WARRAGUL AND DROUIN PRECINCT STRUCTURE PLANS

REVIEW – 2020

Consultation Draft– June 2020

Strategic Planning Unit
Baw Baw Shire Council
June 2020

Plan 2 – Future Urban Structure

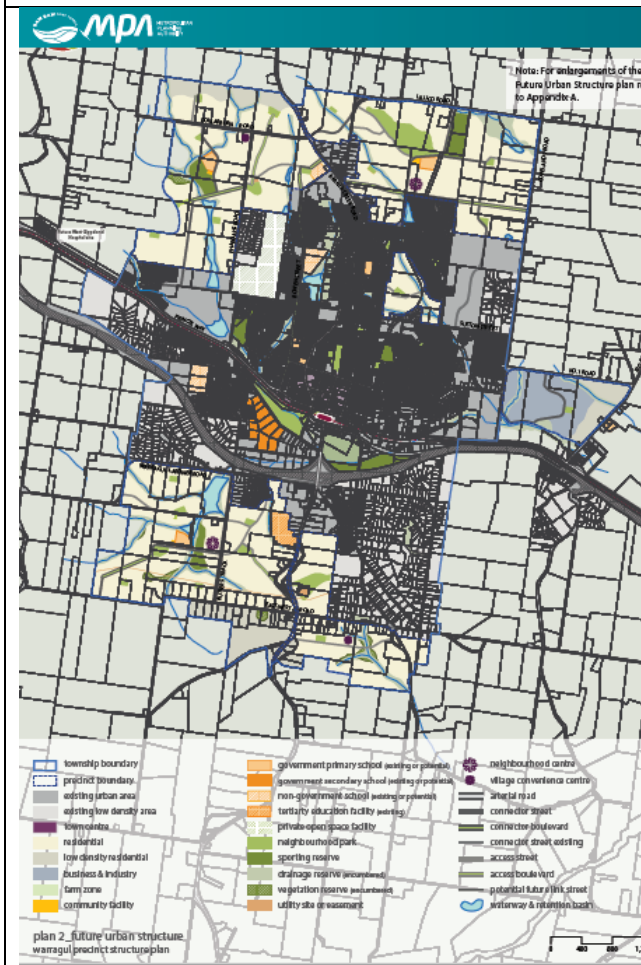
- Update the Plan to show the new locations for the Government Primary School and the Community Facility (south of the Lillico Sporting Reserve SR-02)
- Amend the Plan to show the existing network of local active and passive recreational reserves and potential new linkages that could be developed

Plan 7 - Street Networks

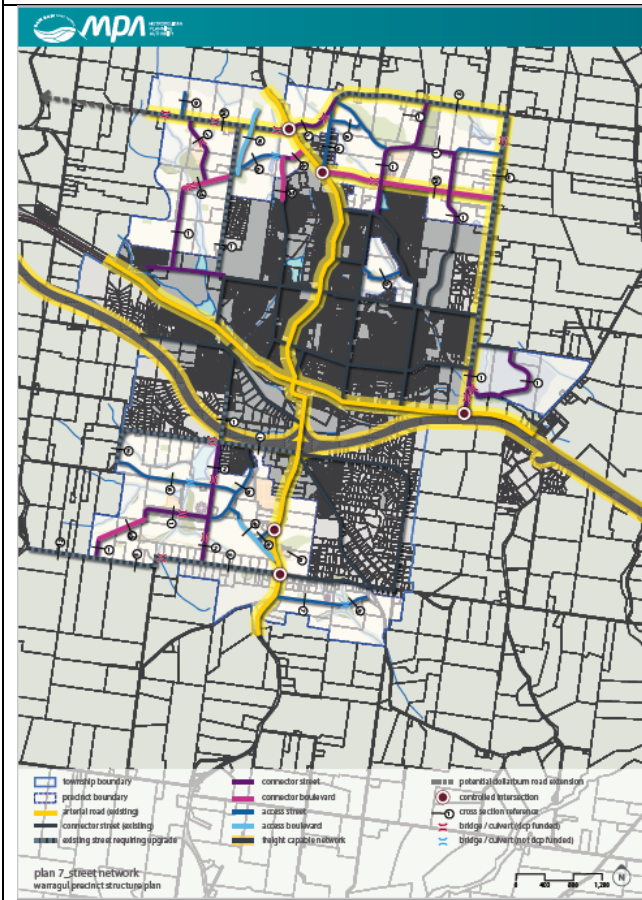
- Amend the plan to show '*Freight Capable Network*' as indicated in the legend to the plan
- On completion of the current Review of the Development Contributions Plans (Schedule 2) include any new projects on the plan (as needed)
- An appropriate new location for the Warragul-Korumburra Road and Murdie Road roundabout is currently being considered (DCP ID INA-SW-01). After the new location is finalised, update the plan to show the new location for the roundabout
- A '*further investigation required*' note to be included in brackets to '*Potential Dollarburn Road extension*' shown on the legend. Details of this extension and cost should be explored. Until such time this cannot be required or imposed on planning permits, as such the above note is required.

Plan 8 – Public Transport and Path Network

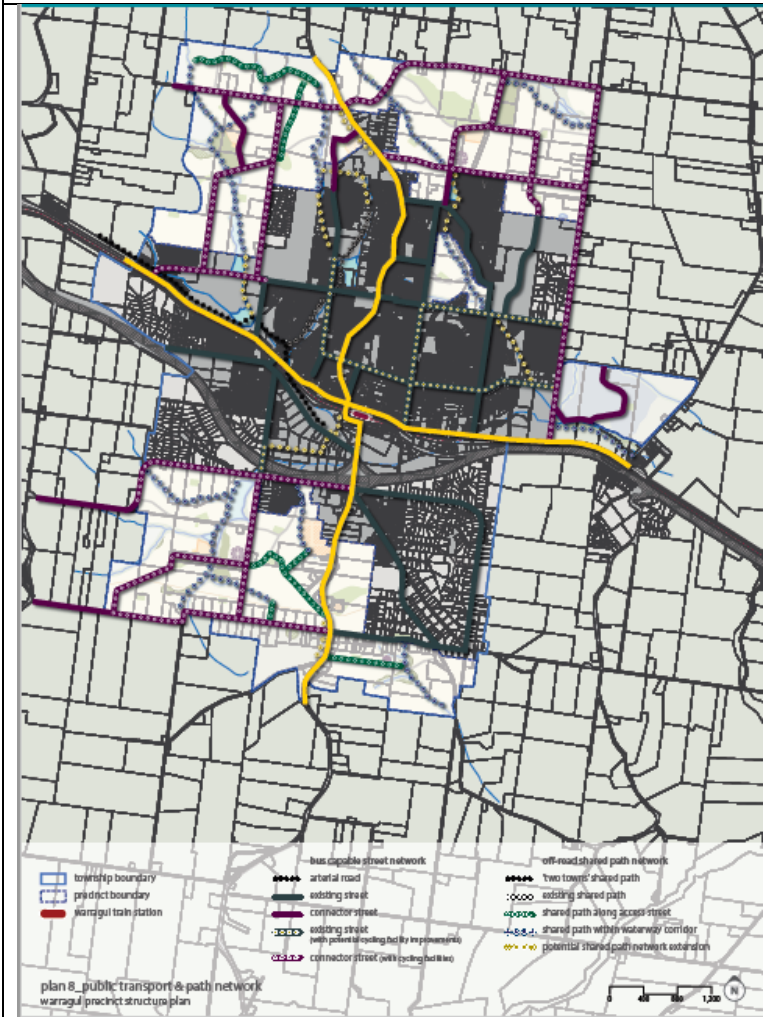
- A 'further investigation required' note to be included in brackets to 'potential shared path network extension' and 'existing street (with potential cycling facility improvements)' both shown on the legend. Details of these projects and cost should be identified. Until such time these cannot be required or imposed on planning permits.

Plan 3 – Township Character

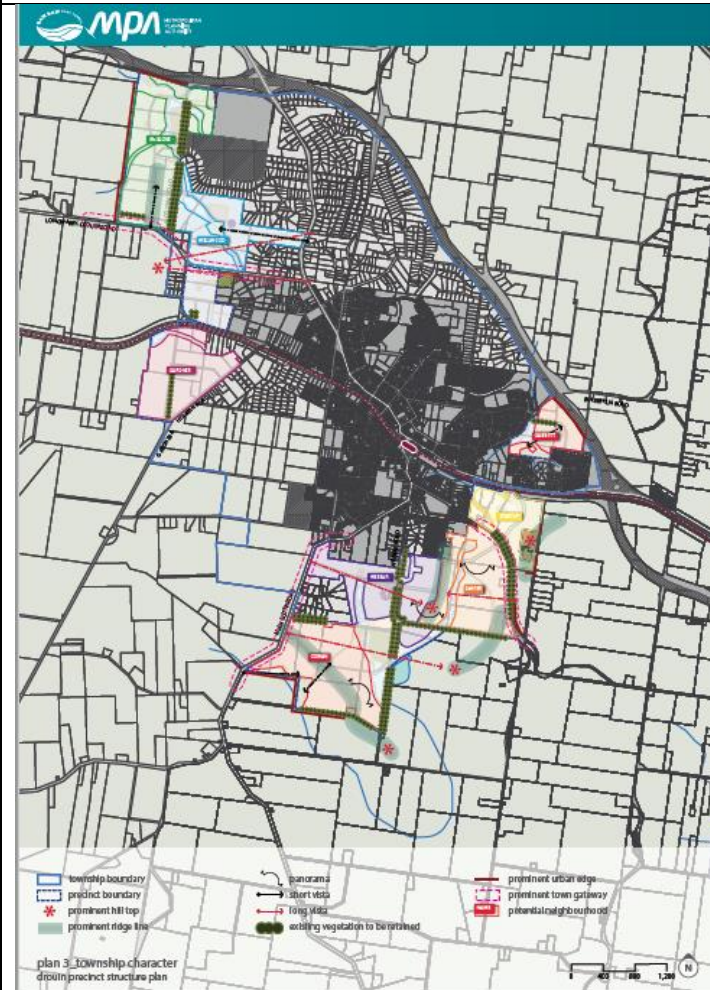
- The plan needs to provide details of vistas to be protected or created (e.g. view of a scenic landscape, a hilltop, other natural features or a prominent structure etc.)
- Plan to be amended to show the correct locations of the prominent hilltops, panorama, existing vegetation to be retained, prominent urban edge and prominent town gateways
- Prominent Urban Edge and Prominent Town Gateway shown on the Plan require design treatments, which are not currently available. Appropriate design treatments to these Prominent Urban Edge and Prominent Town Gateway could be identified by a Gateway Strategy which is recommended to be undertaken.

Plan 5 – Open Space

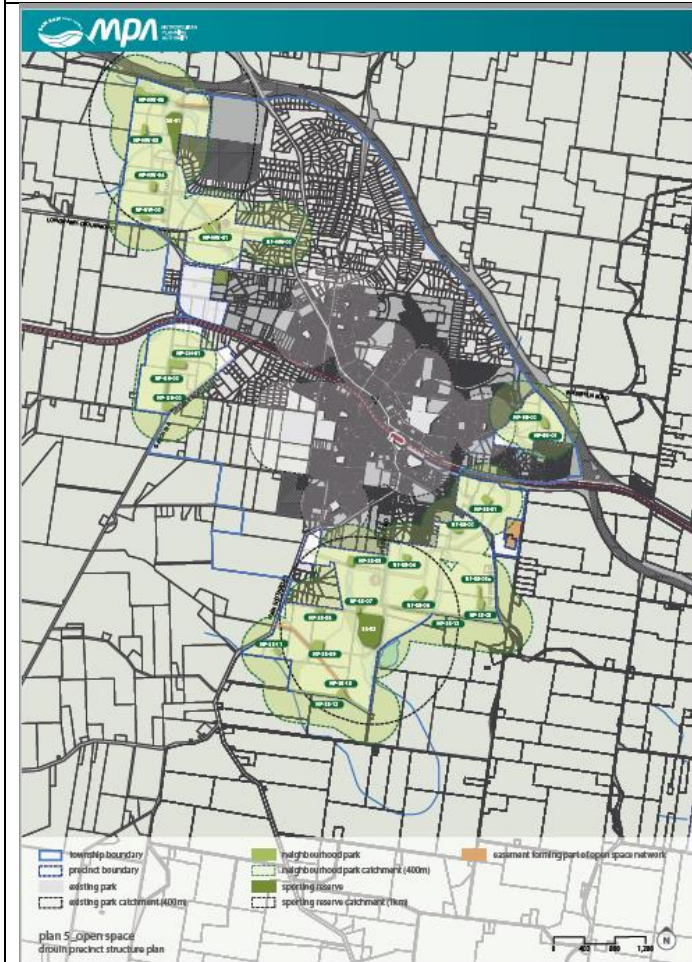
- Update the Plan to move the neighbourhood park NP-SE-05 to its new location (further west towards Main South Road)

Plan 6 – Biodiversity

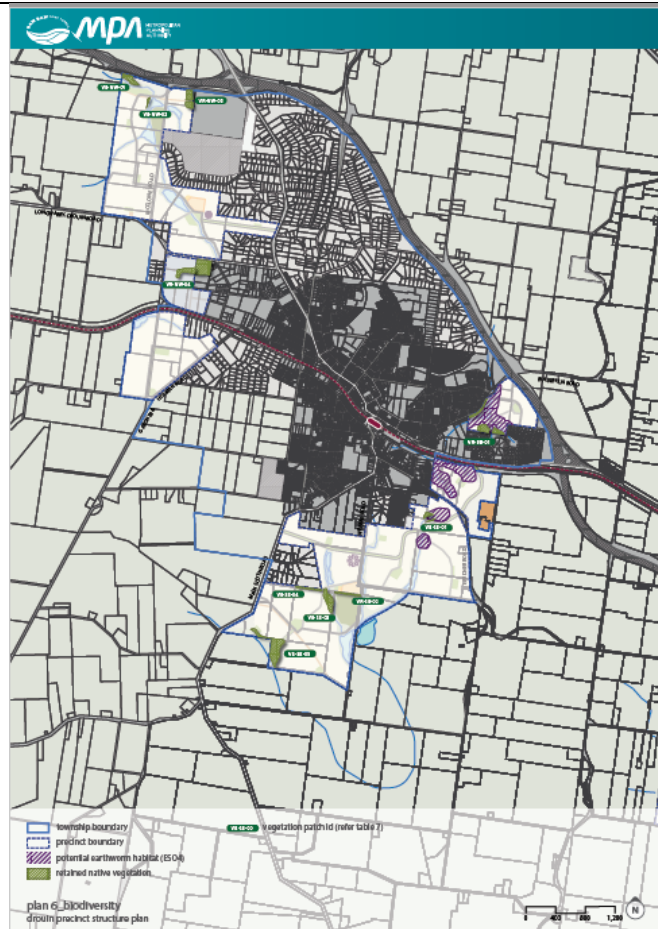
- The Plan refers to Environmental Significance Overlay Schedule 4 (ESO4 that provides protection for potential earthworm habitat). Amendment C108 that introduced Urban Growth Zone into Baw Baw Planning Scheme among other things removed ESO4 from UGZ areas. Reference to ESO4 in the plan is incorrect and should be removed. Similar correction is made to Requirement 29 in Drouin PSP.

Plan 8 – Public Transport and Path Network

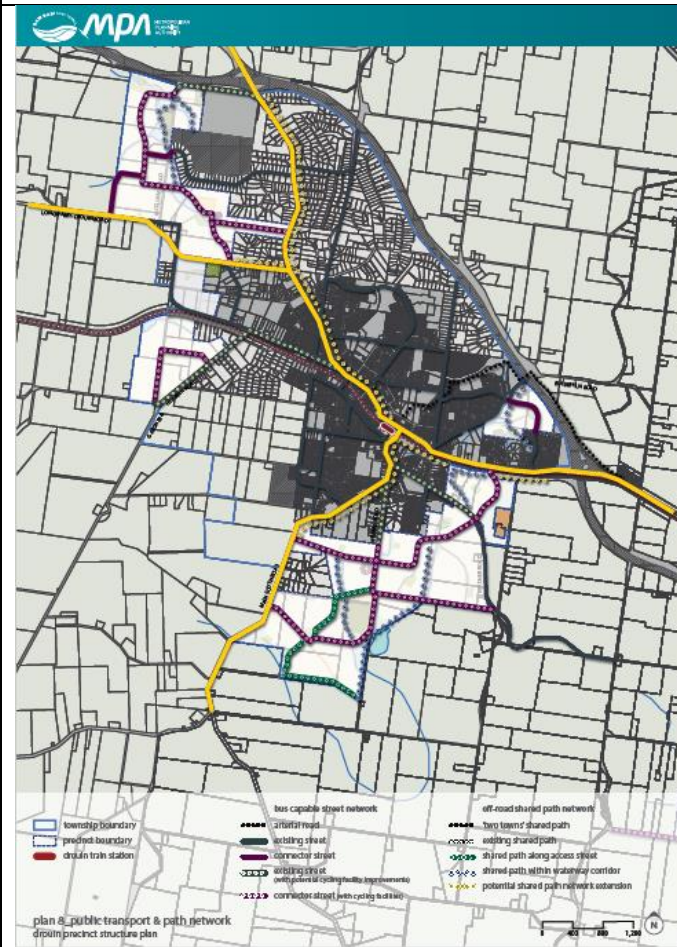
- A *'further investigation required'* note to be included in brackets to *'potential shared path network extension'* and *'existing street (with potential cycling facility improvements)'* both shown on the legend. Details of these projects and cost should be identified. Until such time these cannot be required or imposed on planning permits

Logan Park Wetland

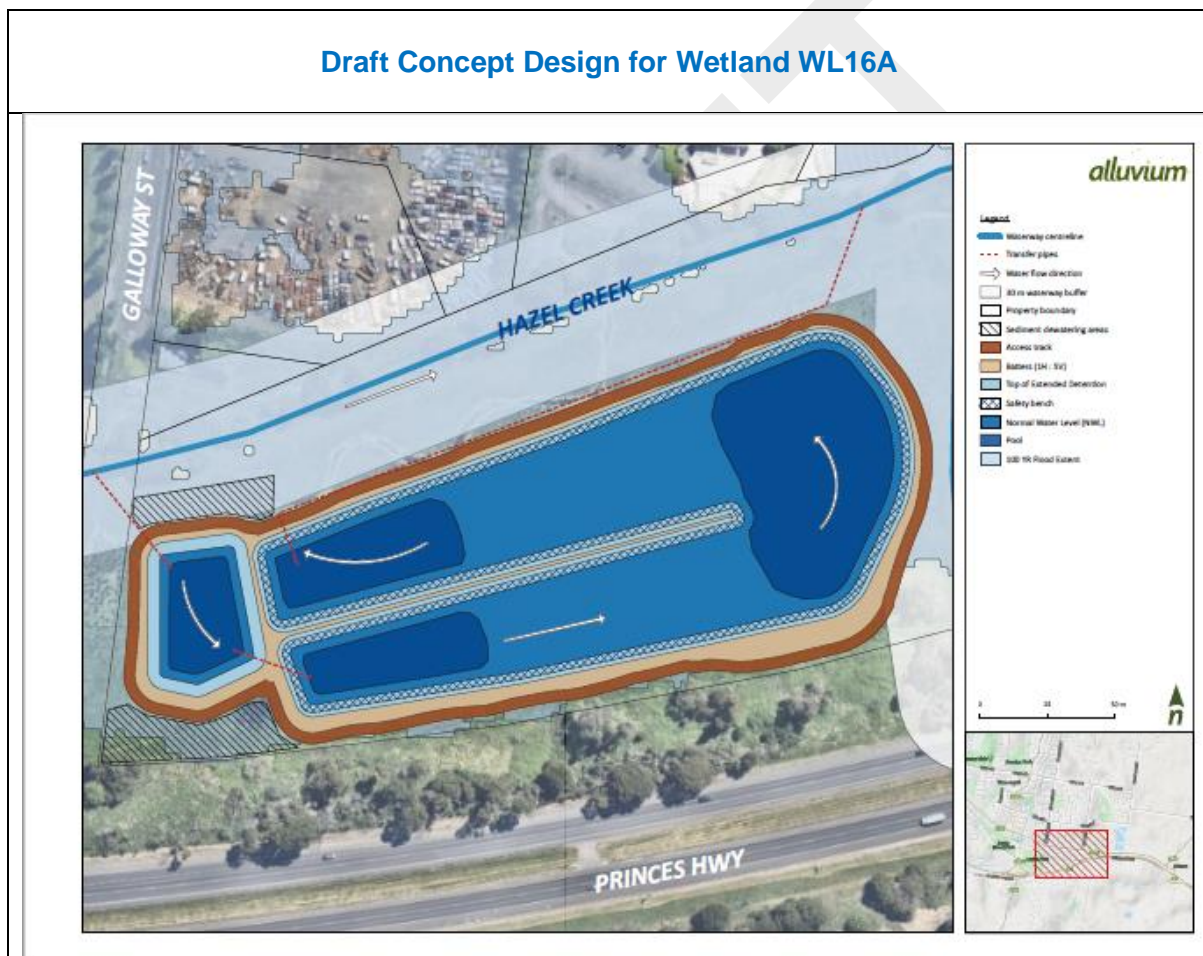
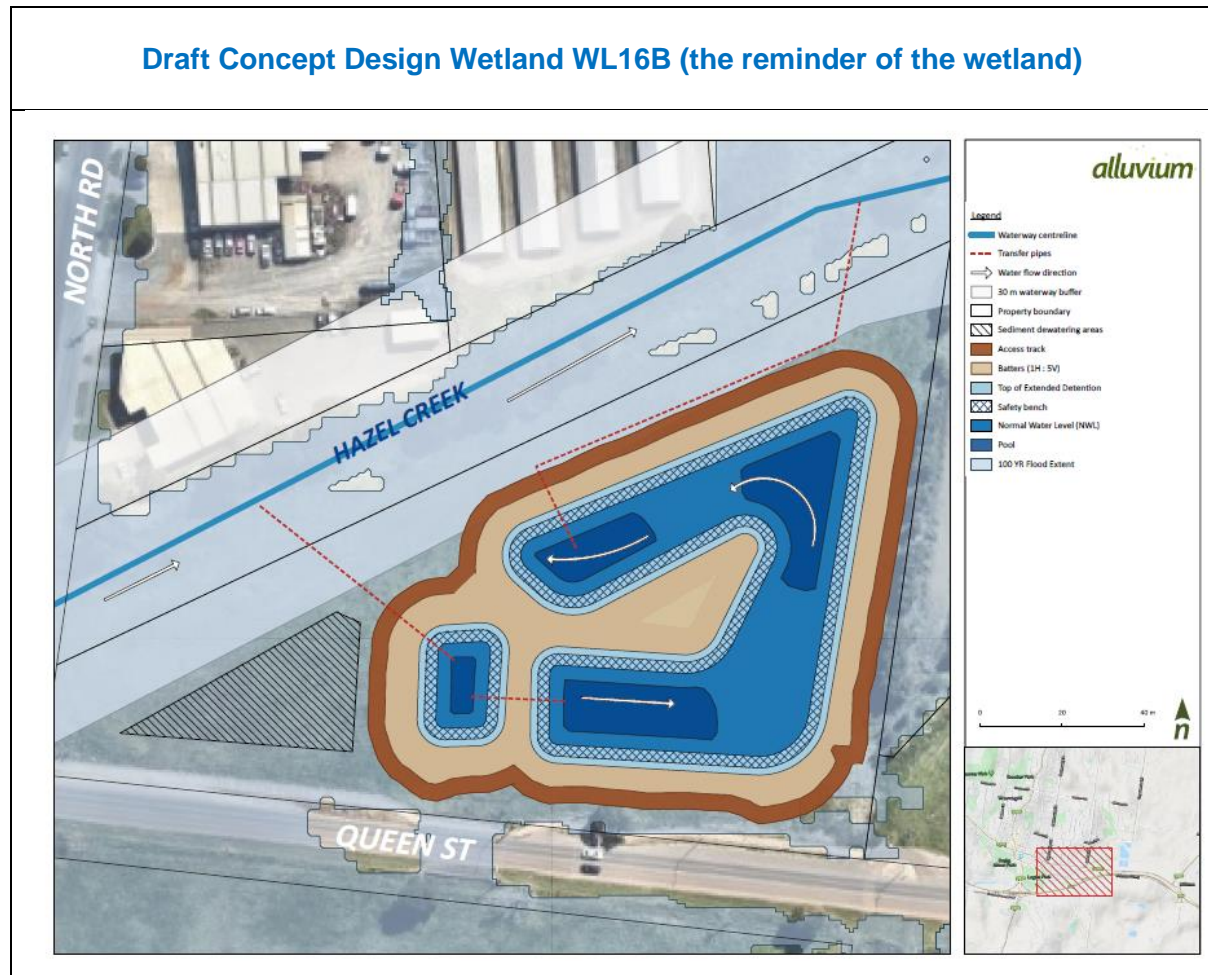
In order to accommodate the above commitment, it was decided to provide WL16 in two locations. The larger portion of the wetland (WL16A) to be located within the available part of Logan Park, and the remainder of the wetland (WL16B) to be in a suitable location nearby. Accordingly, the initial design of Wetland (WL16) was revised (copied below) to accommodate the larger portion of the wetland approximately 21,132sqm within Logan Park.

Additional land required for the small wetland to meet the shortfall was investigated. Due to its proximity to the Warragul Township, Warragul PSP areas, the larger Wetland WL16A and Hazel Creek the vacant land located on the north east corner of North Road and Queen Street (North Road Warragul, part of Lot A LP217081) was found suitable to accommodate the remainder of the small wetland approximately 4,840sqm. The draft concept design developed for this small wetland is copied below.

If the above location for the small wetland (WL16B) is supported, negotiation with the landowner needs to commence to purchase the land. If the land needs to be formally acquired a Public Acquisition Overlay (PAO) should be applied to the land within the Baw Baw Planning Scheme to secure the land when needed (this is included in the additional tasks required section).

Attachment 3: Drainage reserve to be added in the Vegetation Reserve - Drouin PSP

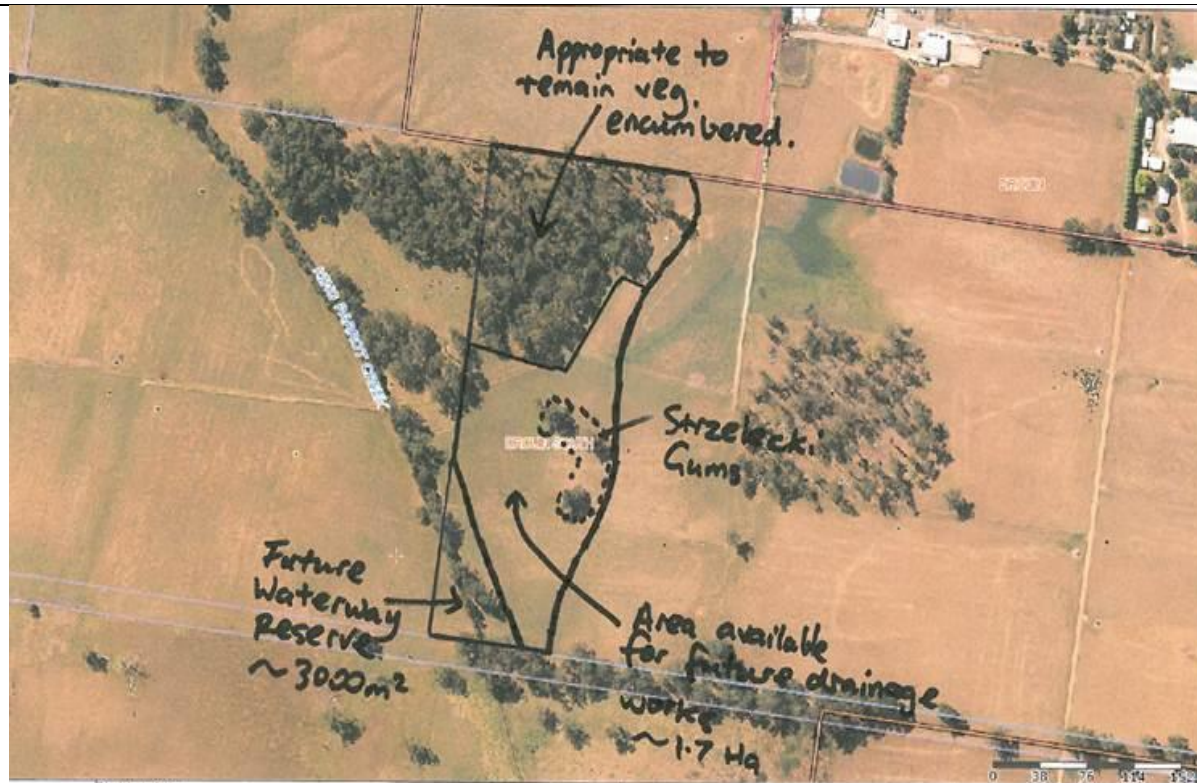
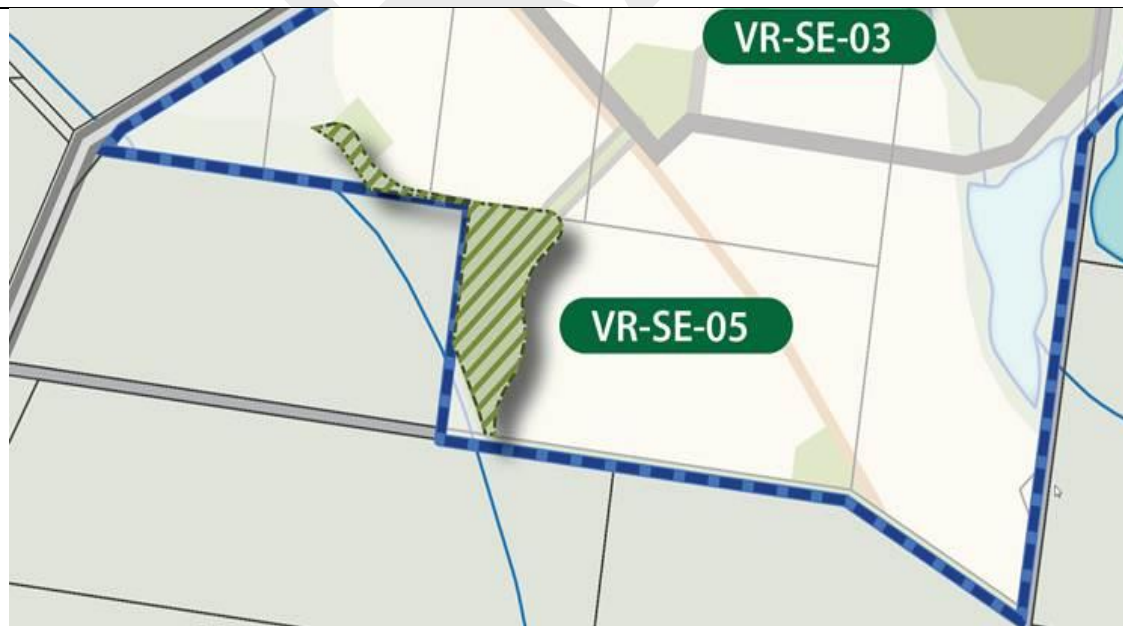
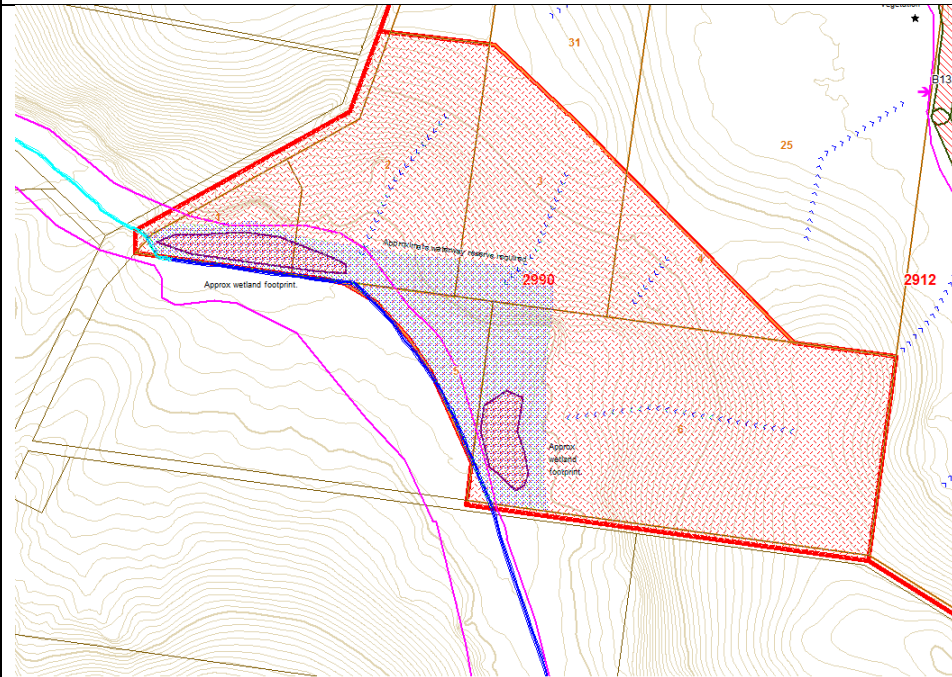
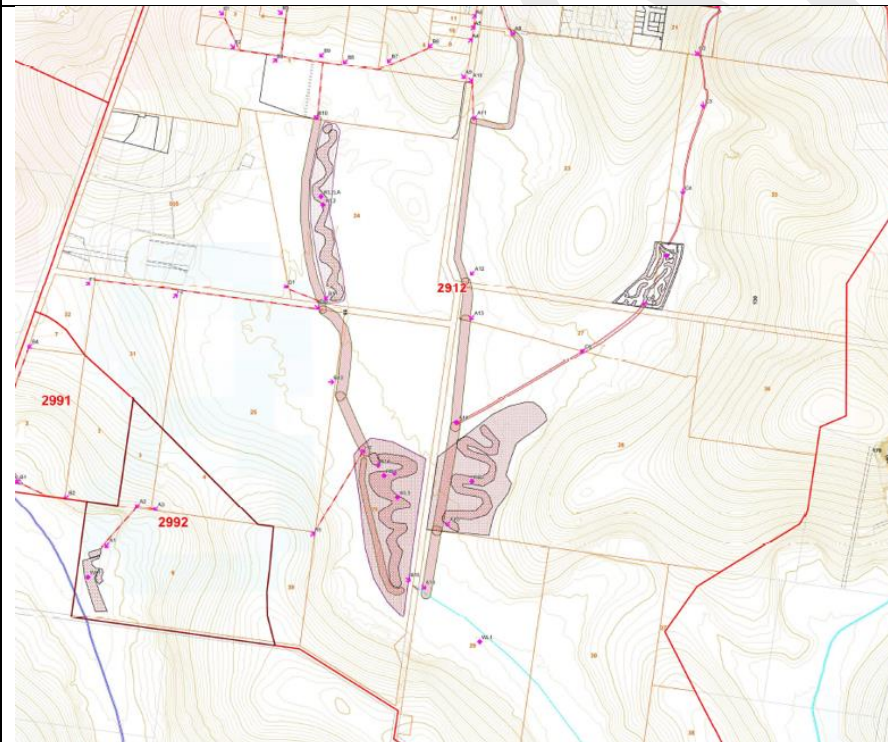
Indicative area to be changed from vegetation encumbrance to drainage encumbrance

Indicative area for drainage encumbrance
